**James City County Environmental Division
Stormwater Management/BMP Record Drawing &
Construction Certification Review
Tracking Form**

County Plan No.: SP-41-05

Project Name: Third High School (Waxhill HS)
Structure/BMP Name: Third High School BMP
Project Location: Southwest of the Intersection of U.S. Rt. 60 and Rt. 199
BMP Location: South End of School Site
County Plan No.: SP - 41 - 05

POND MAINTENANCE RECORD DRAWING
OF
PC-204
LOCATED AT
WARHILL HIGH SCHOOL
FOR
JCC STORMWATER DIVISION

TEMPORARY SEDIMENT BASIN #1 PROFILE

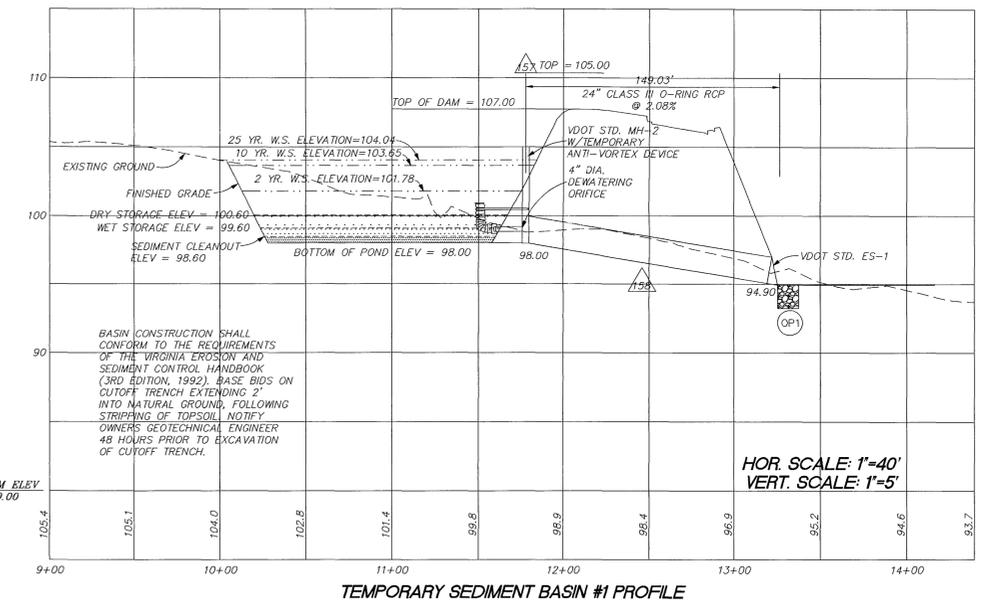
- a. *Previous comment # 20k was not fully addressed. Clarify and address seepage control methods for pipe barrels through temporary sediment basins # 1/# 2 and address previous concerns that VDOT DI-1 flat grates would not comply with Minimum Standard & Spec. 3.14 of the VESCH. It is unclear how the trash rack/anti-vortex tops for the temporary sediment basins, as shown on Sheet C2.6, are to connect to the DI-1 riser units. The basin must conform with Minimum Standard & Spec. 3.14 of the VESCH.*

Response: A clay core and cutoff trench has been added to the sediment basin (Drawing C2.6) to address seepage control. A toe drain has also been added to the basin dam and 6" of stone under the outfall pipe from the clay core to the toe of dam will also help water migrate to the toe drain. Refer to Drawings C2.6, C4.2 and C5.1 for notes, details and plan view of the seepage control measures. The reference to DI-1's on Drawing C2.6 has been revised to MH-2's and the flat grate has been replaced by a plastic trash rack (Drawing C2.6).

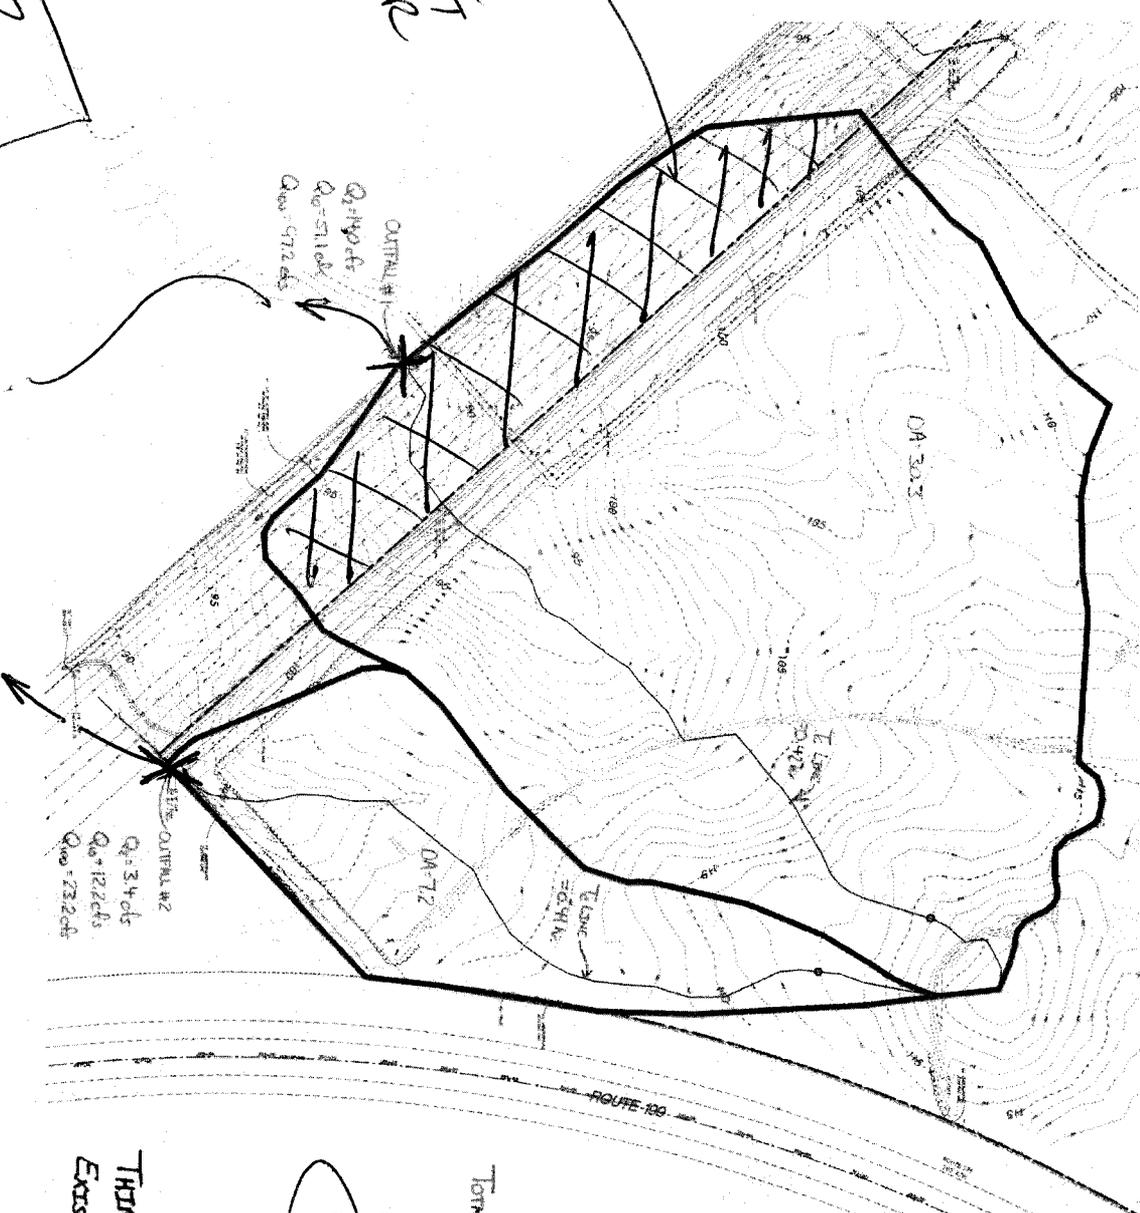
4. TR 55 - why were PreDev and postdev sed trap comps done by hand but TSB postdev hydrology was done using Pondpack 9.0. Be consistent

5. PreDev CNOF 63 - show composite breakdown woods - HSG. Confirm

6. Tc - Need comp's for all Tc assumptions. Overland, S/H cone + channel flow components. Path shown NOT CHANGE for outfall #1 and ANALYSES

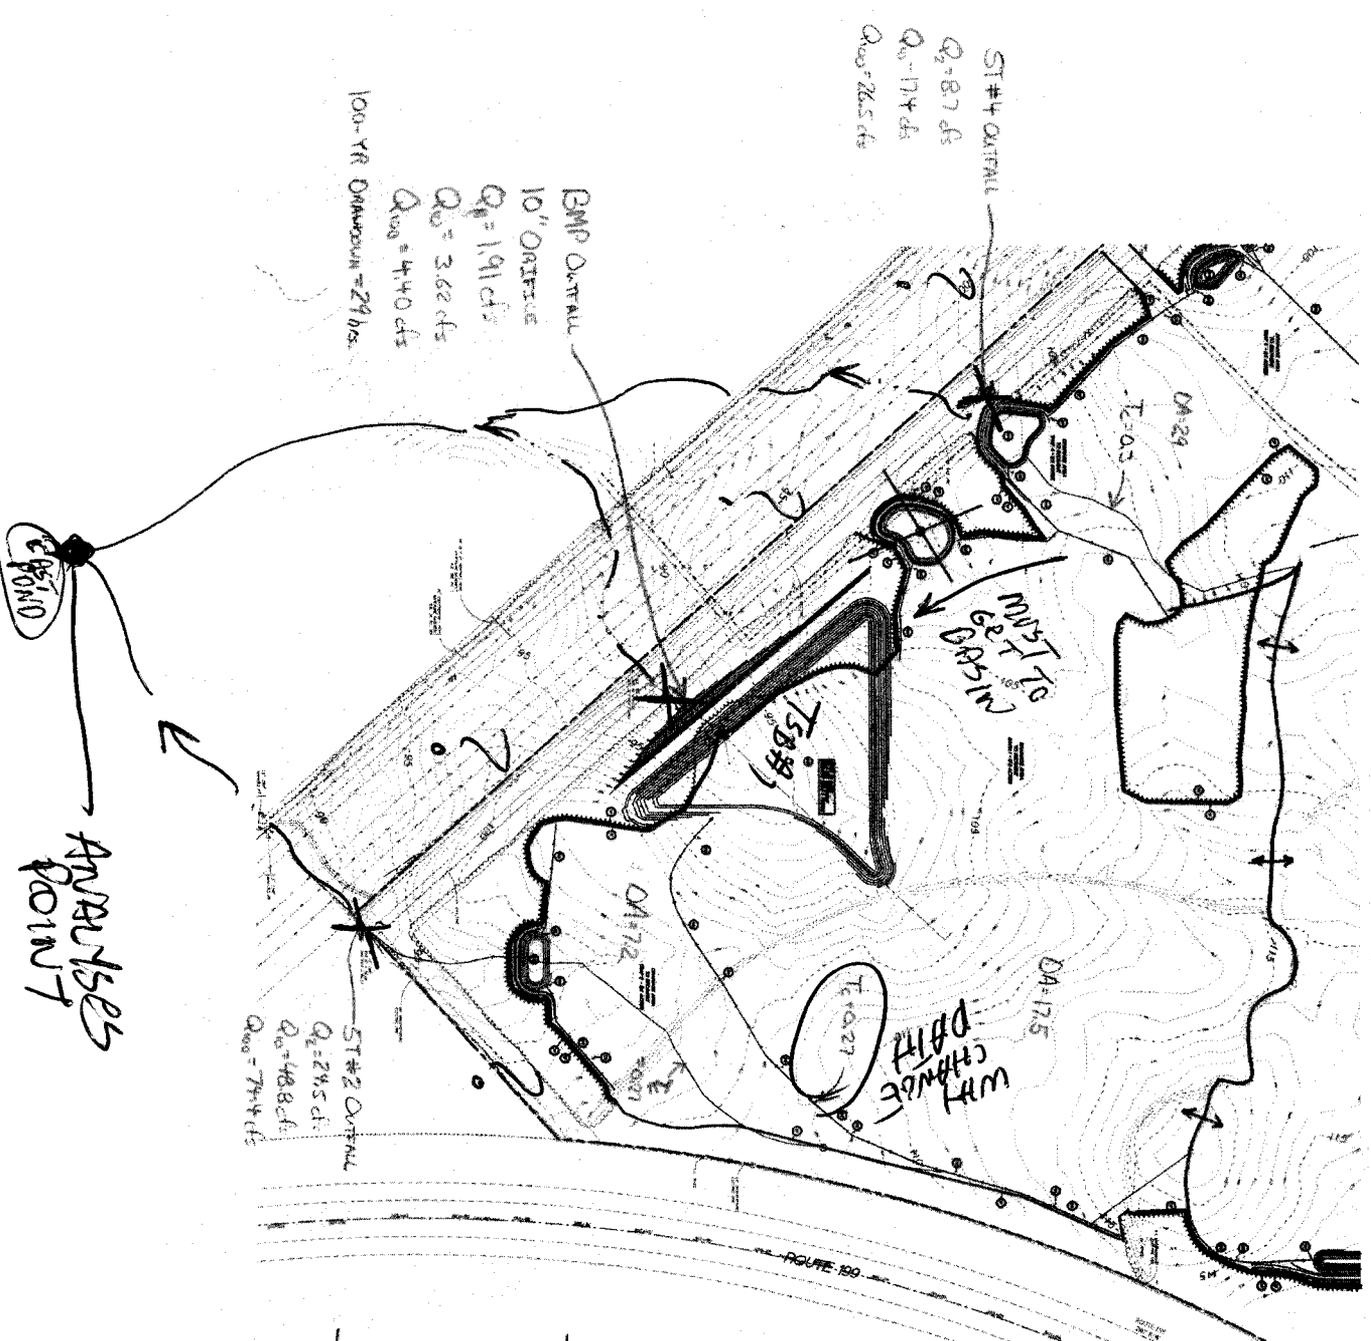
you can't
just add...

EX. CONDITIONS
 Q_{N-63} ✓
 check w/ neighborhood
 and cond. #56?
